**Community Development Department Memorandum
Development Review Division**

Regarding: Public Meeting:
Site Plan Amendment: Kneader's Bakery at Lot 1, Parker Central Area Filing 11
19190 E. Mainstreet
[Application AMD 13-055]

Re: **Parker Central Area Filing 11 Lot 1 (Kneaders) - Site Plan
2nd Public Works Review**

**LIGHTING /
 PHOTOMETRICS
 PLAN**

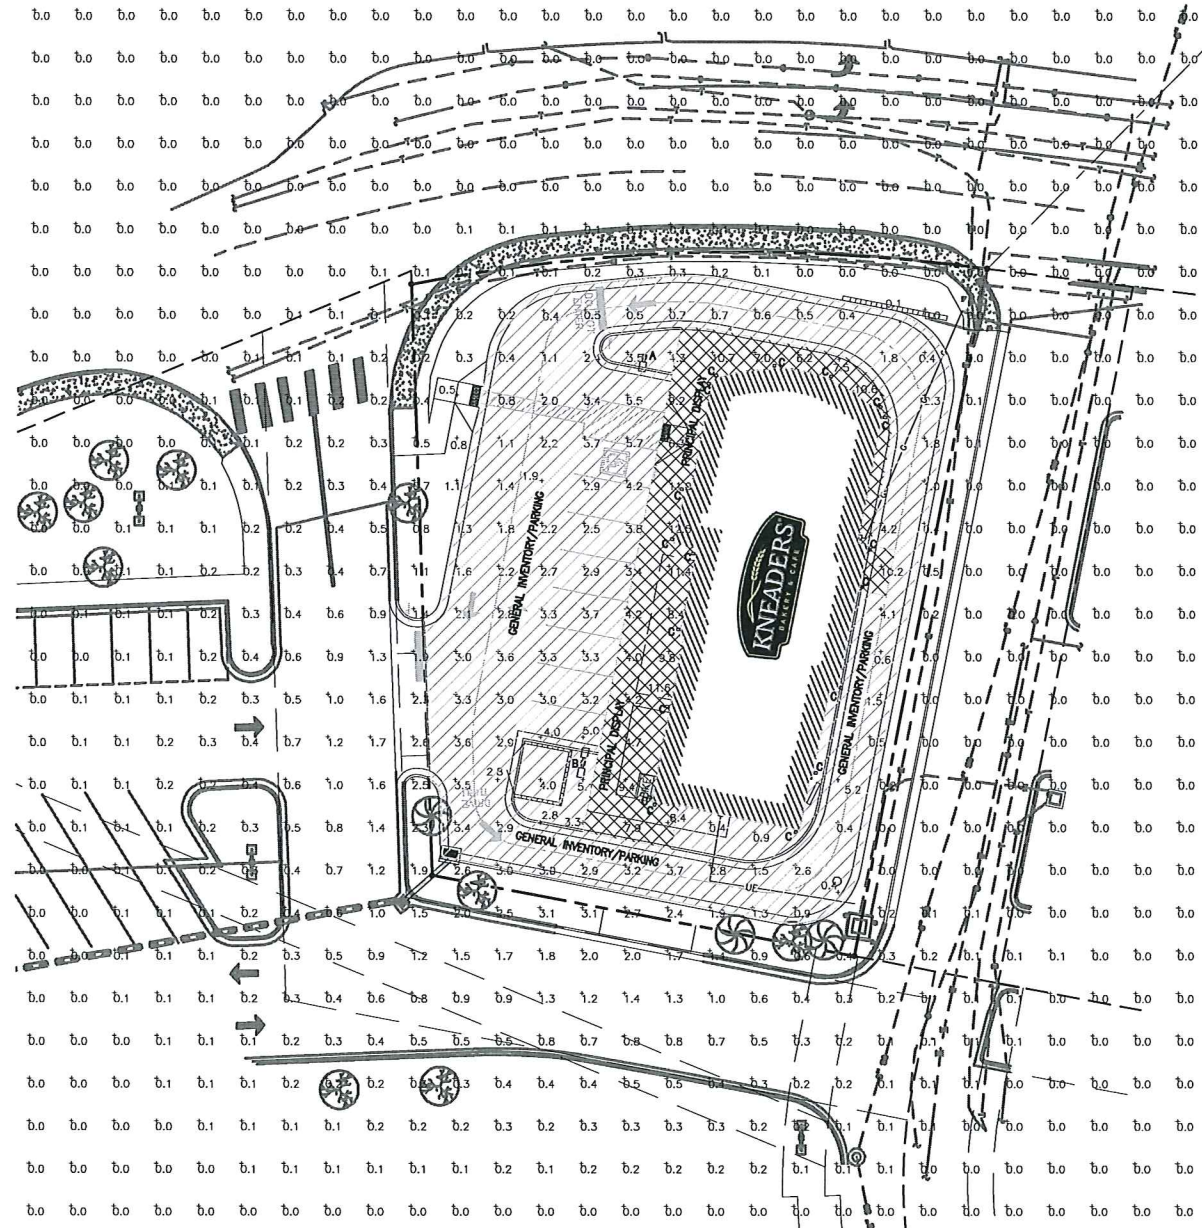
- E-1 Refer to the Lighting /Photometric Plan and Detail sheets:
- 1.) The light fixtures listed on the exterior lighting fixture schedule are different from the light fixtures indicated on the photometric lighting detail.(ie: The triple 4-pin 42-watt florescent fixtures are shown as 70-watt metal halide) ***Please provide revised exterior lighting compliance certificate at building plan submittal***

FRONT EXTERIOR ELEVATIONS 1
 1/4" = 1'-0"

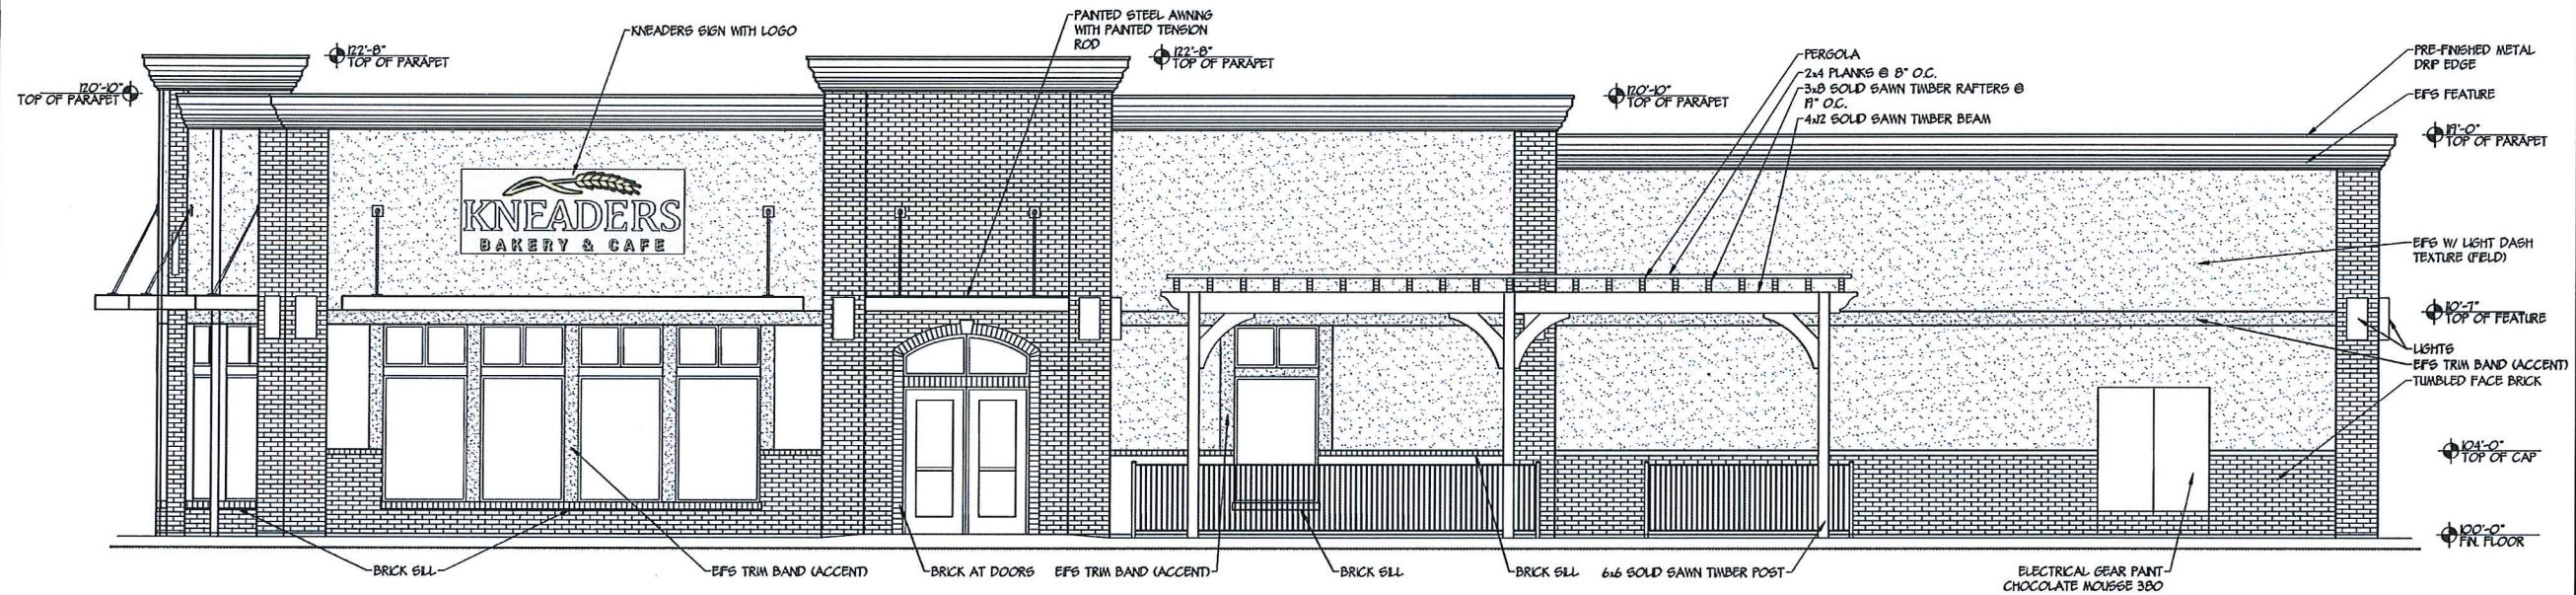
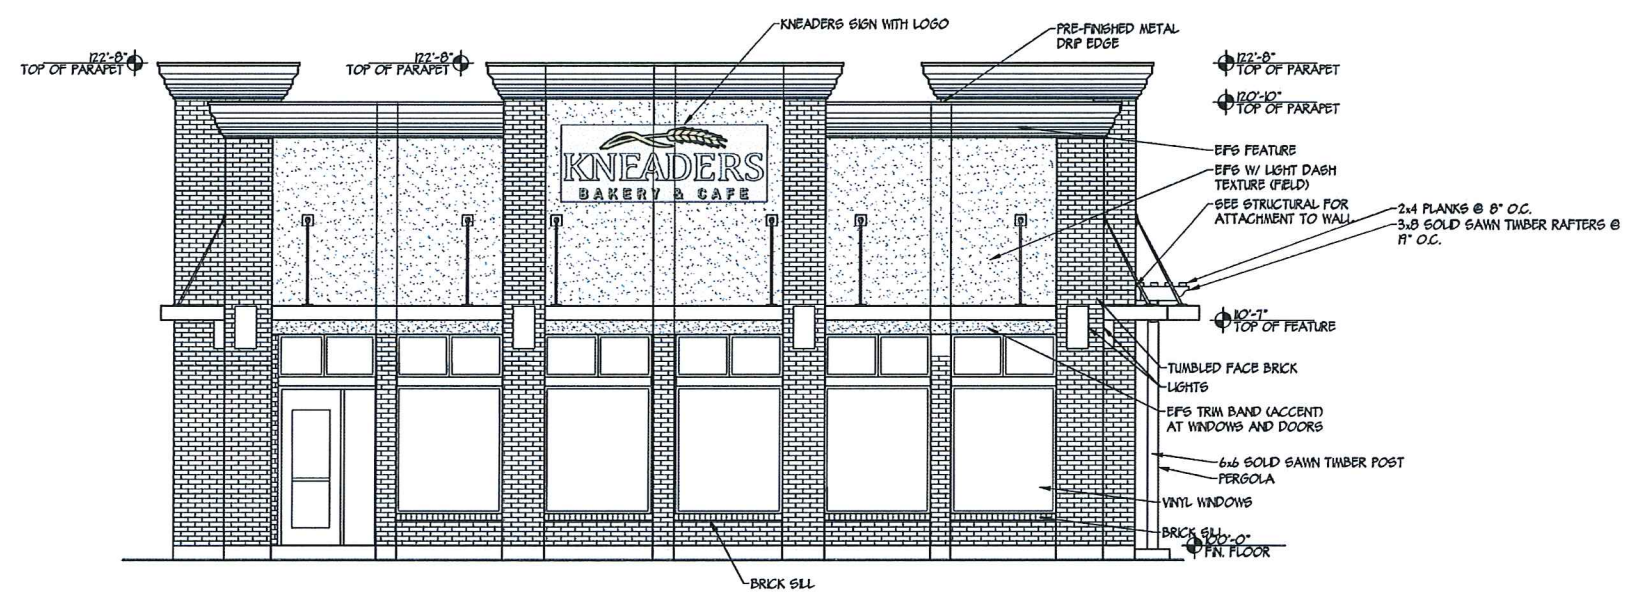
There are only two issues related to materials and colors which staff believes may require additional scrutiny: the first issue is the prominence of the door on the north (Mainstreet) elevation so as to activate this elevation when viewed from Mainstreet. The second issue involves the materials to be applied to the three-foot concrete wall to architecturally link it to the building. A condition of approval has been added to this report to address both issues.
